N6741B-01

S E R V I C E N O T E

N6741B 100W DC Power Module

Location of C36 and C37

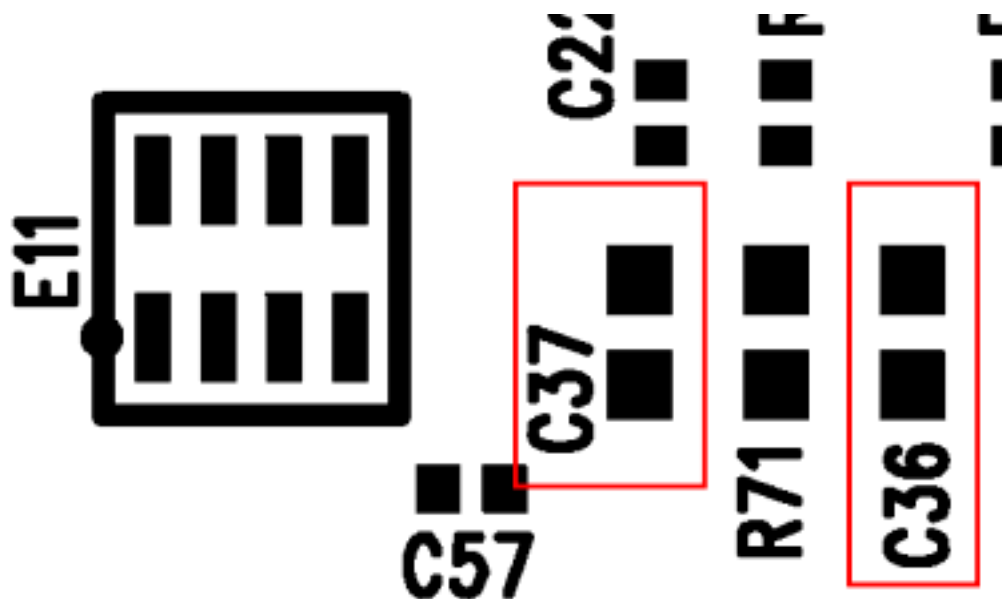
Due to some noise filtering issues, the current measurement accuracy will be out of specification by a fixed offset when there is a voltage being sourced at the output terminals. If the output is shorted, the current measurement accuracy will be within specifications. Please note that the performance verification test will not catch this.

If this measurement is out of specification, replace capacitors C36 and C37 on the DPM assembly (this is the assembly that is vertically mounted in the unit that looks similar to a PC memory module) with part number 0160-7809. After the capacitors are changed, the unit will require re-calibration. After the capacitors are replaced, check the make sure that the unit is in specification by applying 75% of the full voltage range while attached to a load drawing 50 mA to 70 mA. If the current measurement is within the specification, then the unit has been repaired.
